SCDF

Common Audit Issues

Cl.4.2.3e.(3)(b)

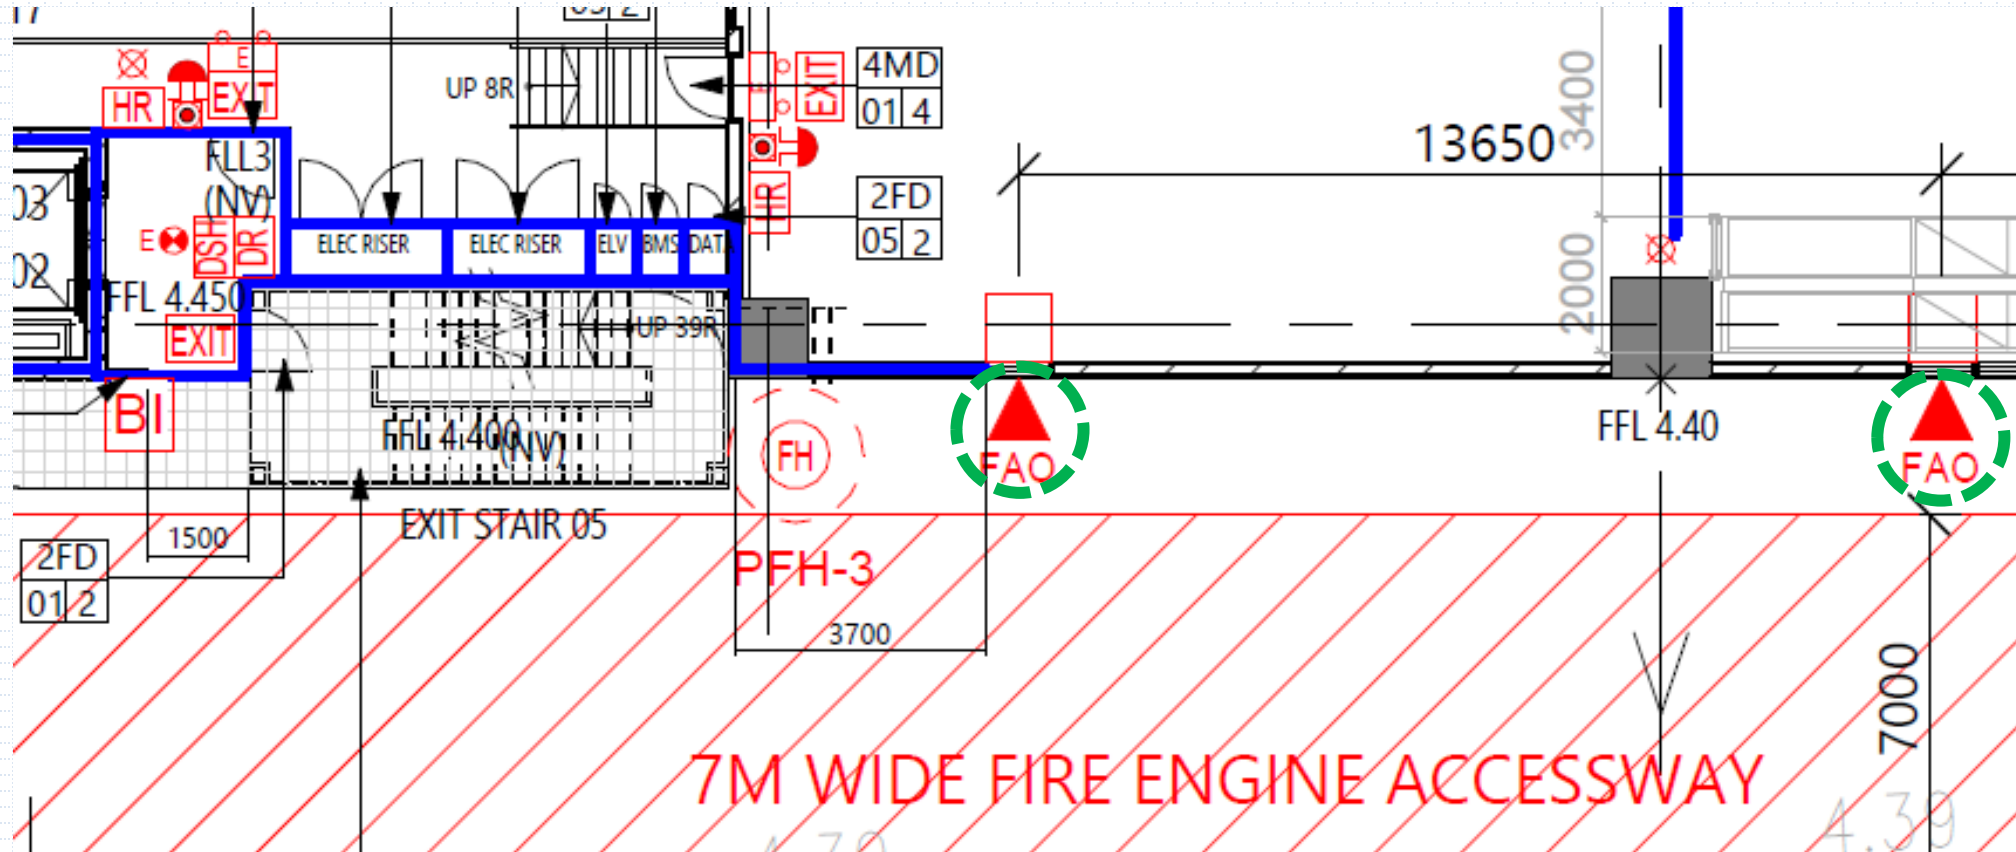
❖ Correct example

Cl.4.2.3e.(3)(b)

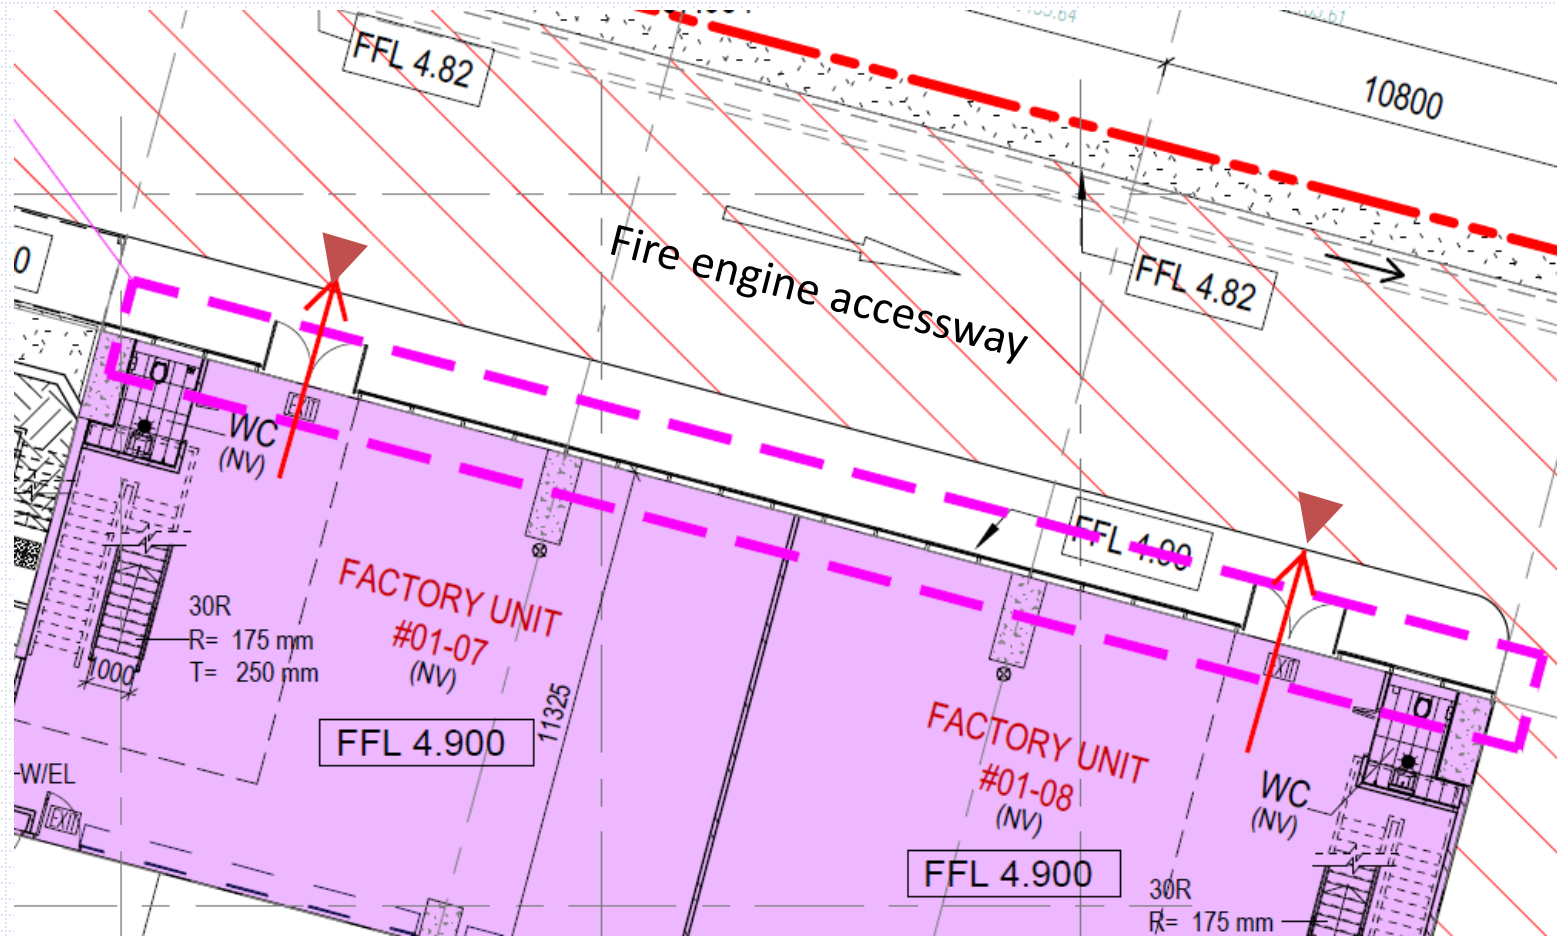
- ❖ Doors can double as FAO, if it is readily openable from the inside and outside. FAO can also be designed as non-laminated breakable glazing.

Cl.9.3.3e.(3)

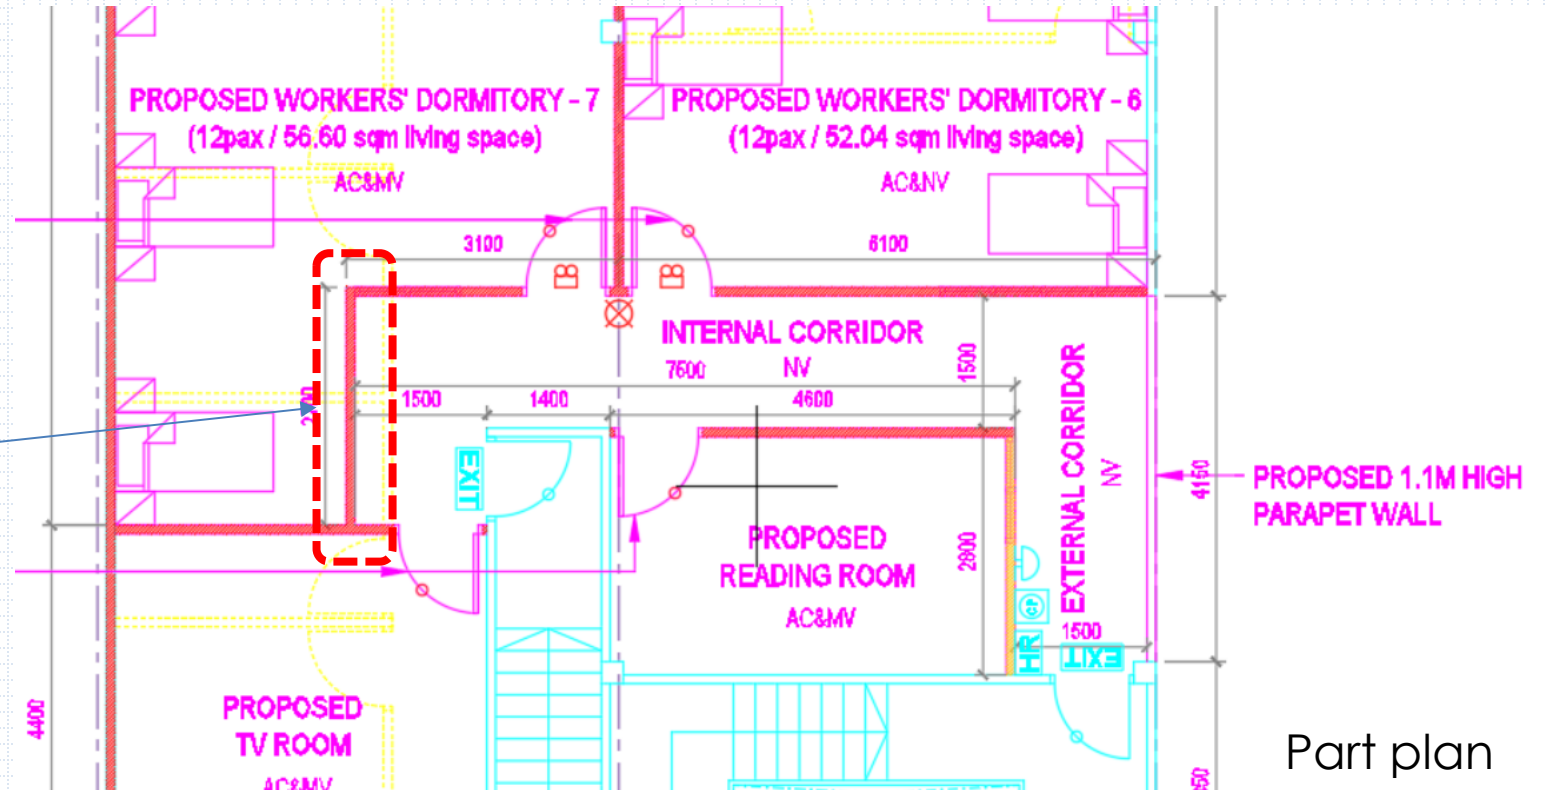
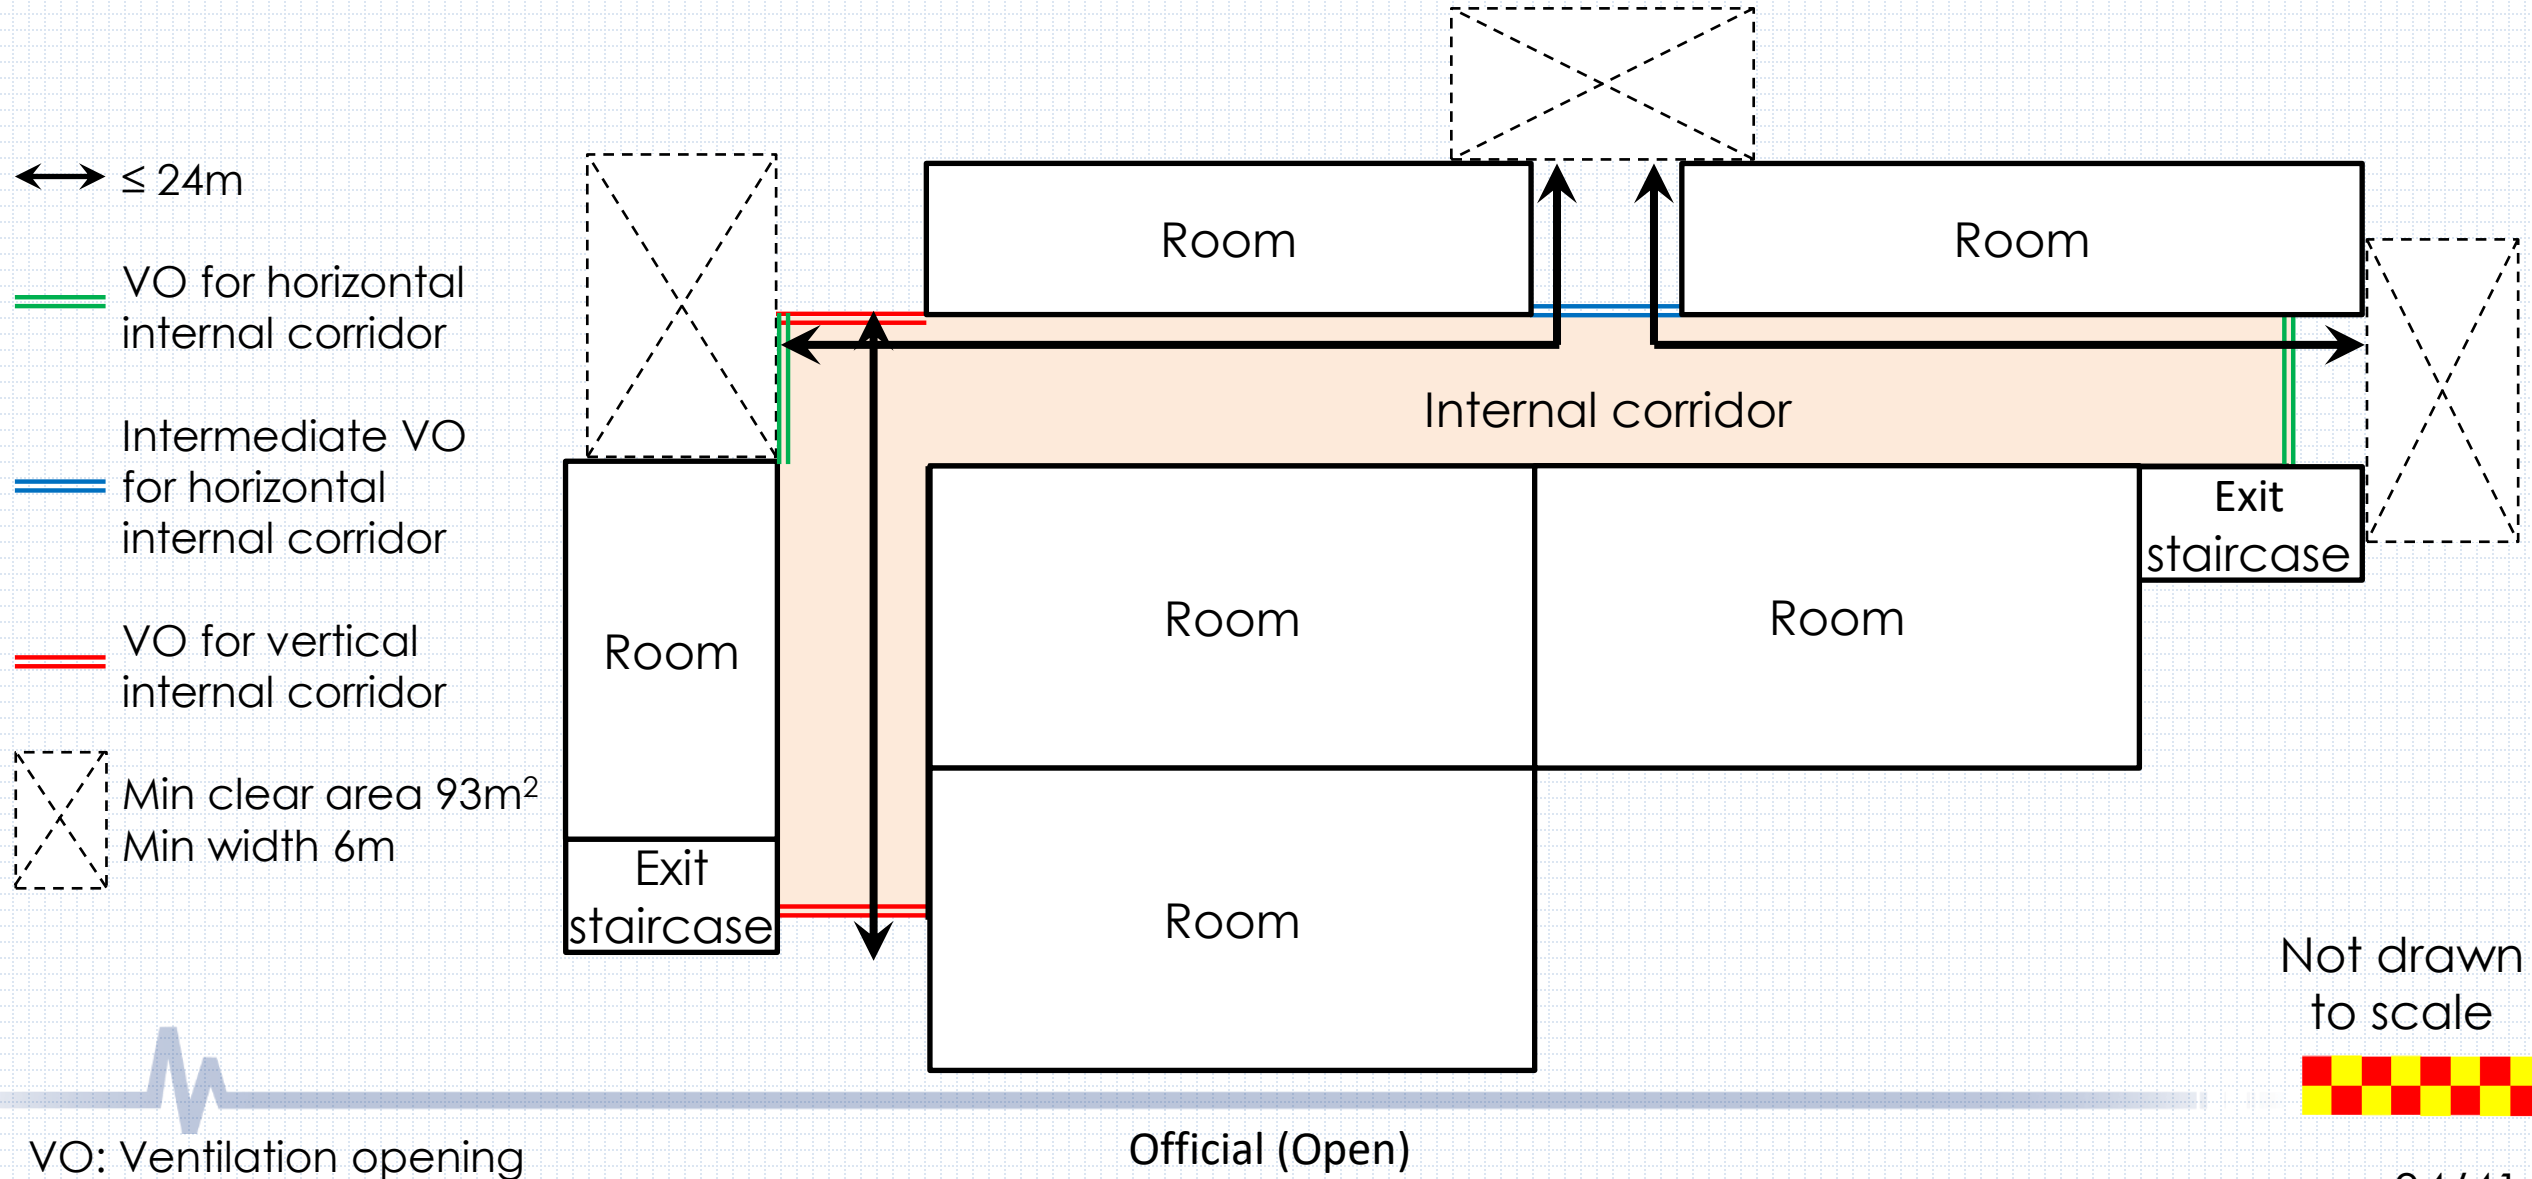
- ❖ Mistake: Non-provision of effective cross ventilation to the internal corridor to dormitory bedrooms

Non-provision of ventilation opening

Cl.2.3.10f.

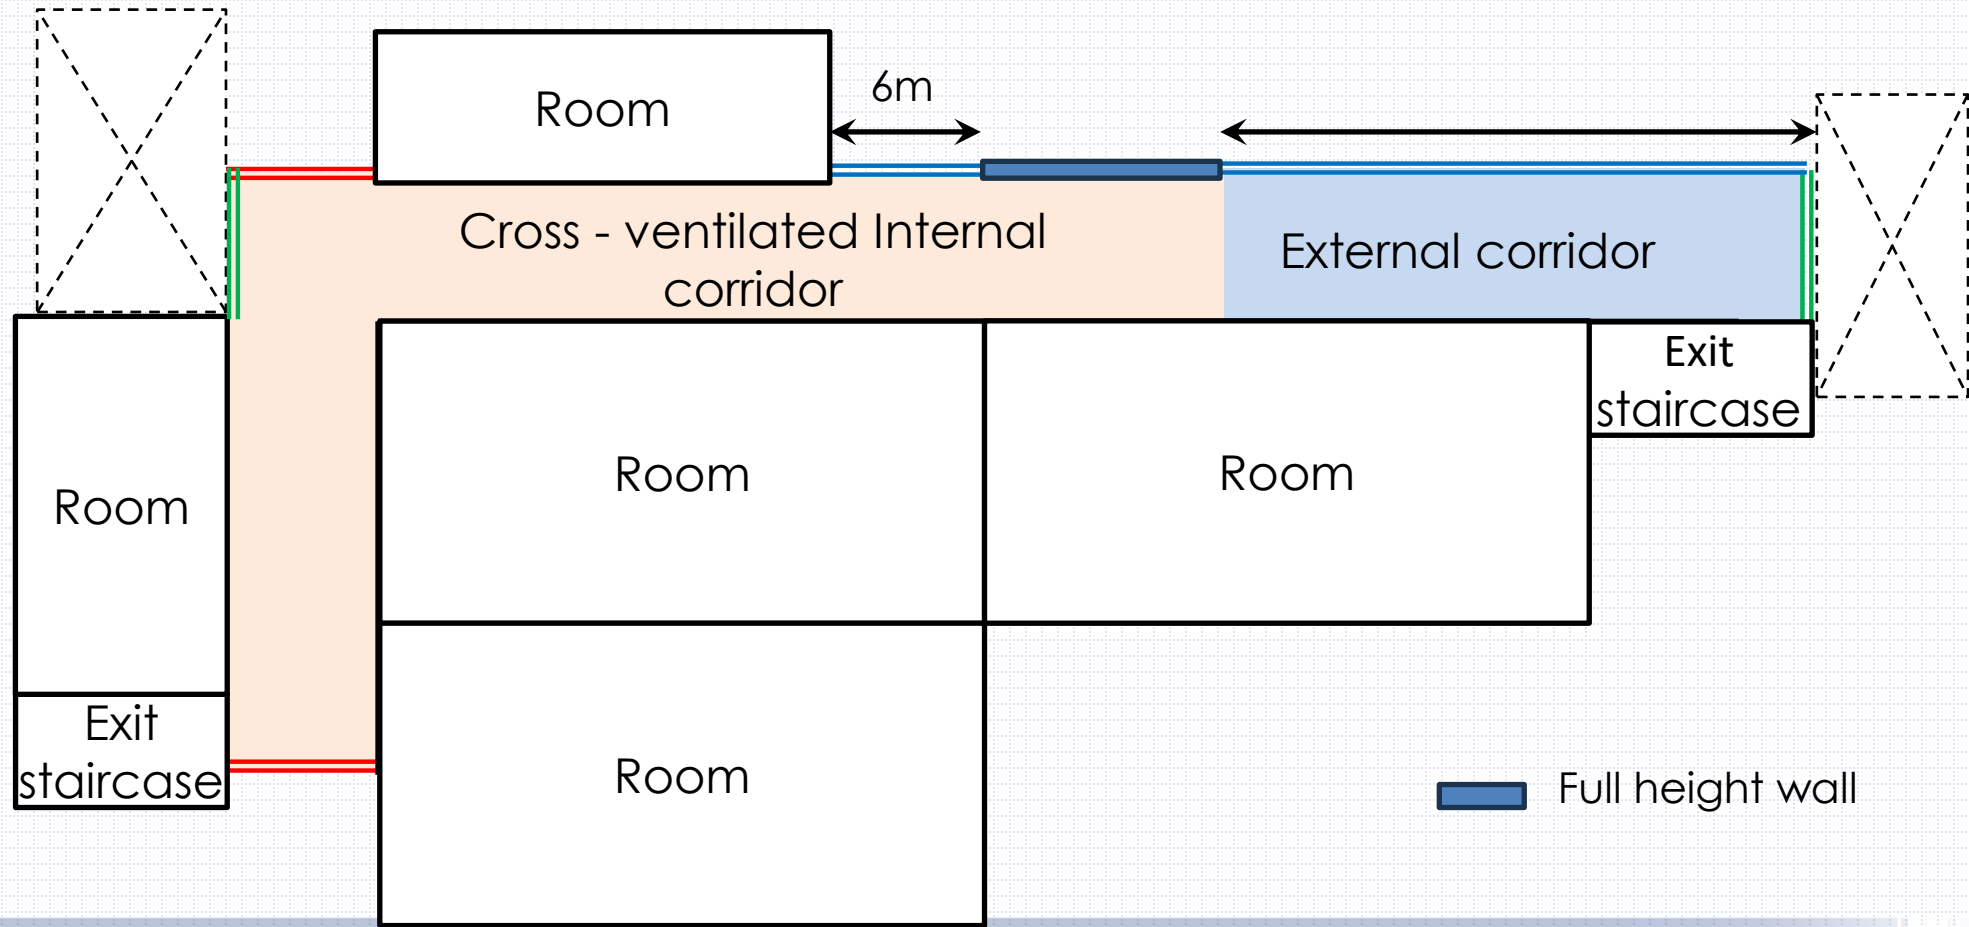
- ❖ Rooms fronting internal corridor shall comply with internal corridor requirements. Cross ventilation will be measured up to opposing walls.

Cl.7.4.4a.

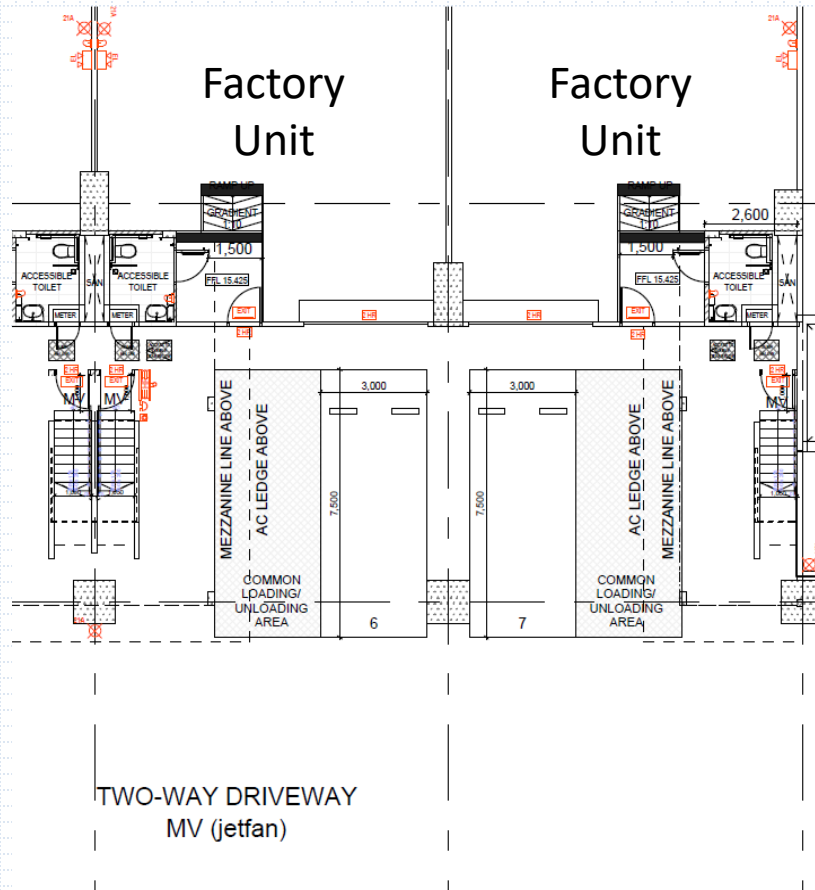
- ❖ MV Jet fan should be provided based on heavy vehicles assumption
